OBJECTIONS TO PROPOSED WORKS AT 33 WILLOW ROAD [PA 2019/5140/L & 2019/5141/P]

PETITION

This document outlines the concerns and objections to the submitted planning application for proposed side extension basement works to heritage asset Grade II listed 33 Willow Road, Hampstead NW3 1TN from Willow Cottages owners and or residents as listed below

Insertion_Extract 1866 OS map showing water wells along Willow Road relative to Willow Cottages

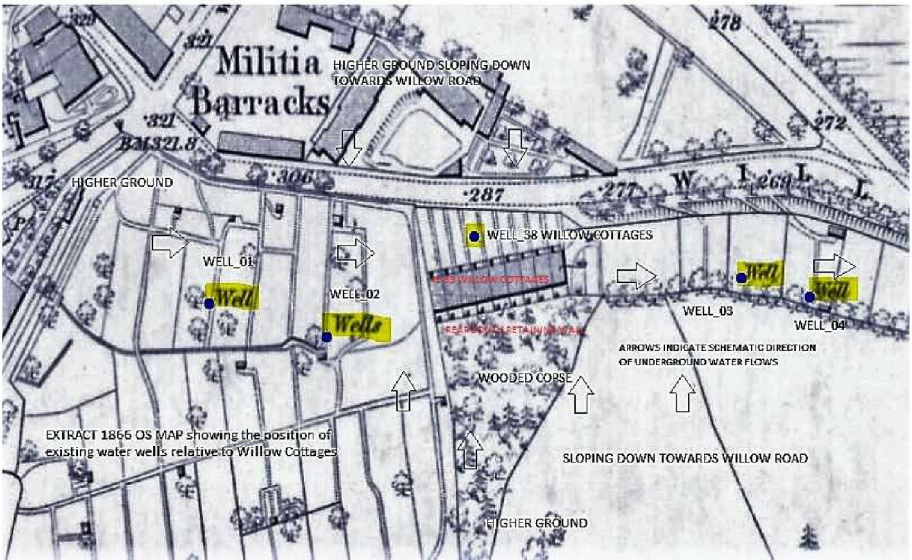
Contrary to the BIA document and its various incorrect statements therein, it is seen that the terrace with its lower ground floor circa 83.36m FFL is in fact vulnerable to flooding. It is fact that [1] the listed terrace properties were flooded in 2002, [2] that the water table is higher than stated in the BIA document [e.g. the water table level as measured in lower front planter of 39 Willow Cottages is only some 500mm above the common LGF FFL]; [3] 38 Willow Road has one of the original water wells in the front garden which is still active and which formed part of the chain of historic wells along Willow Road; and [4] the Listed cottages have underground water flows below the terrace from tributaries of the Fleet that flow down from higher immediate surrounding areas of Old Hampstead naturally converging on Willow Road down to the lower ponds at South End Road and beyond [see Insertion_Extract1866 OS showing wells along Willow Road].
